SUBJECT: COMANCHE PEAK STEAM ELECTRIC STATION (CPSES)  
DOCKET NOS. 50-445 AND 50-446  
INFORMATION TO SUPPORT TECHNICAL SPECIFICATION  
CHANGE FOR LOW-LOW STEAM GENERATOR WATER LEVEL

During the Technical Specification (T. S.) review meetings that took place from February 13 through 24, 1989, TU Electric agreed to submit a safety analysis which demonstrates the acceptability of a low-low steam generator water level safety analysis limit of 0% of the narrow range instrument span. This analysis is used in the development of the setpoints identified as Functional Unit 6.b in T. S. Table 3.3-3, sheet 4 and Functional Unit 13 in T. S. Table 2.2-1. In accordance with that agreement, enclosed is an advance description of a FSAR change which will be included in the upcoming FSAR Amendment 76.

ENCLOSURE TO TXX-89172

FIGURE 15.2-23

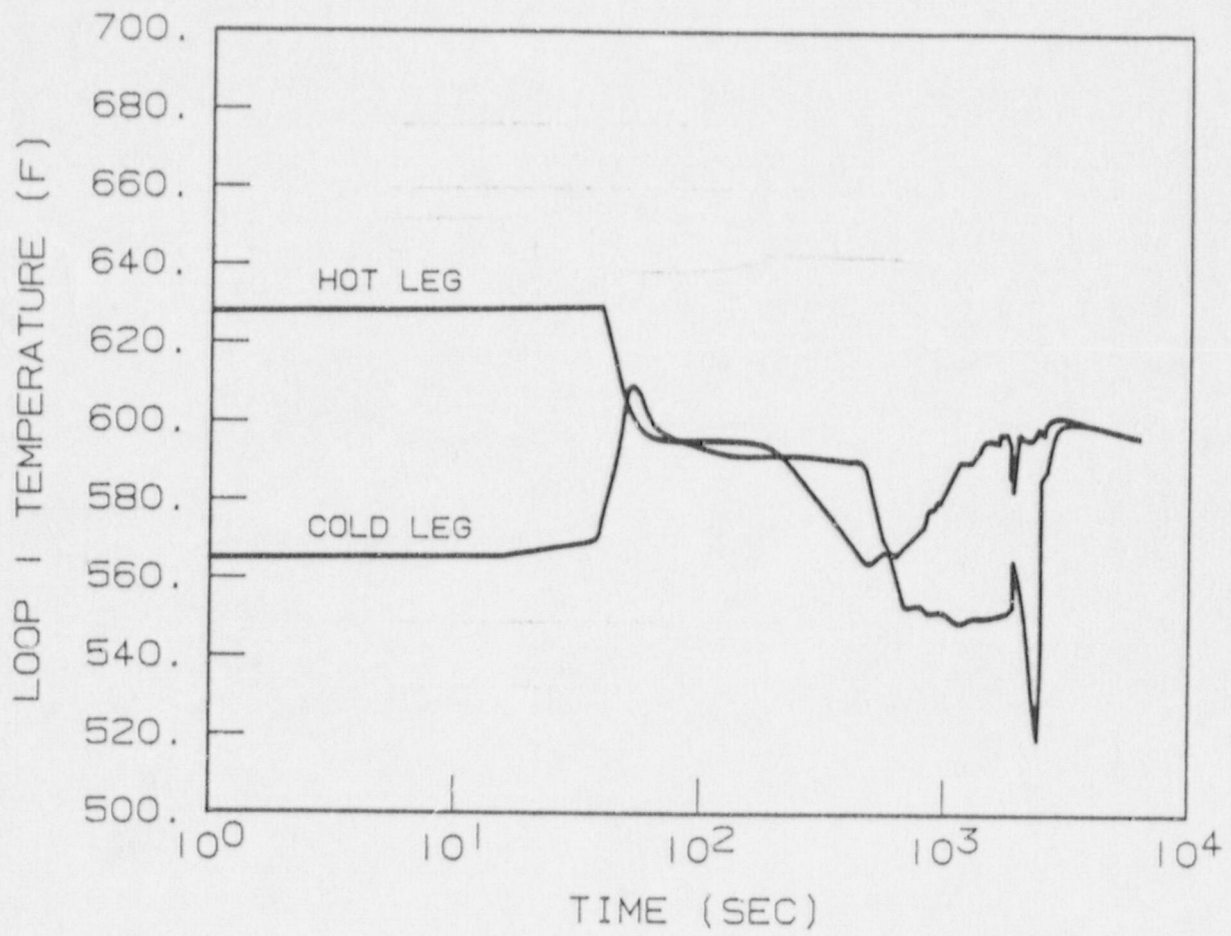
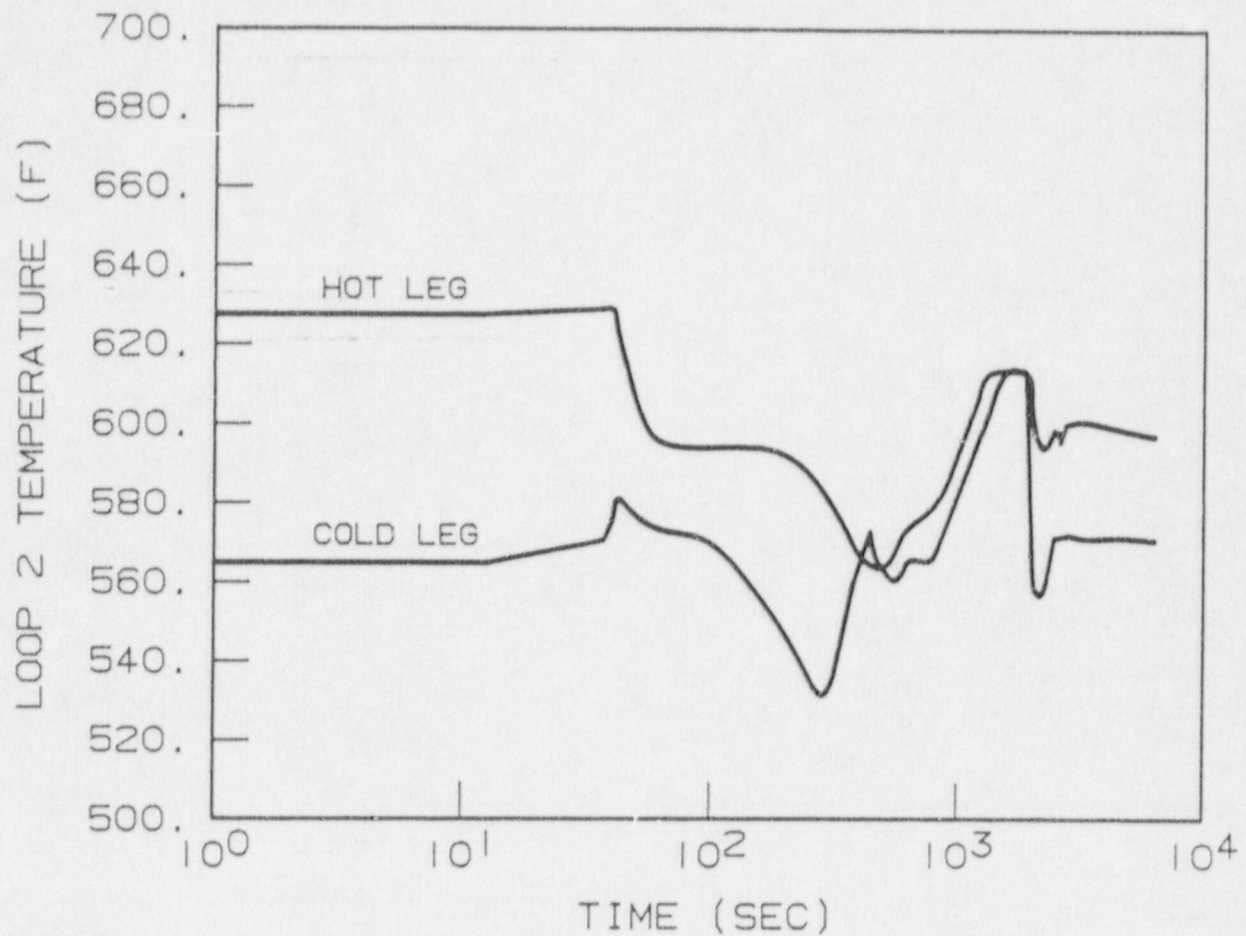
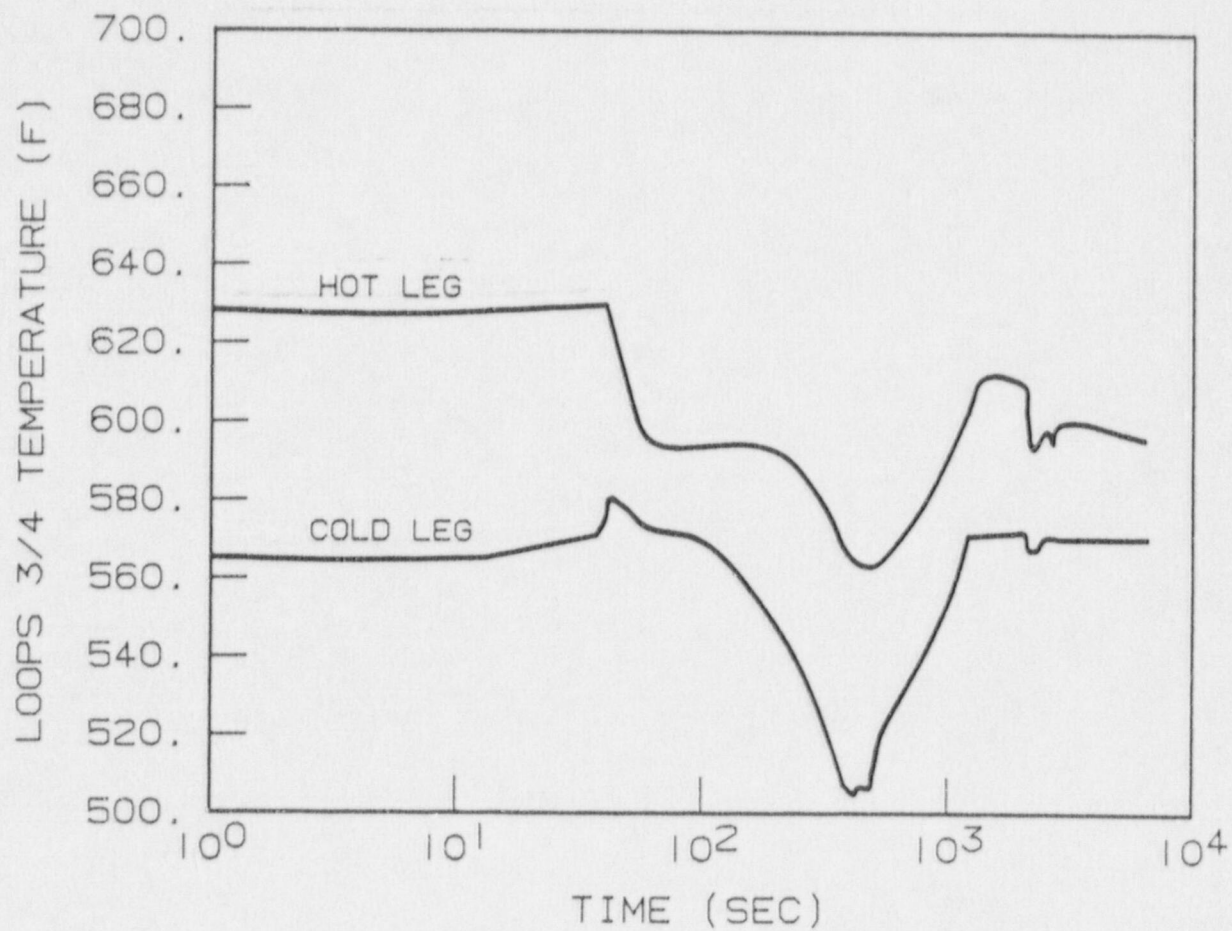
The major difference between the two cases analyzed can be seen in the plots of hot and cold leg temperatures, Figures 15.2-16 through 15.2-18 (with offsite power available) and Figures 15.2-23 through 15.2-25 (without offsite power). It is apparent from the initial portion of the transient (<300 seconds) that the case without offsite power results in higher temperatures in the hot leg. For longer times, however, the case with offsite power results in a more severe rise in temperature until the coolant pumps are turned off and the Auxiliary Feedwater System is realigned. The pressurizer fills more rapidly for the case with power due to the increased coolant expansion resulting from the pump heat addition. *the* ~~however, no water is relieved~~ for ~~either~~ case. *As previously stated, the core remains covered with water for both cases.* *with offsite power available; however,*
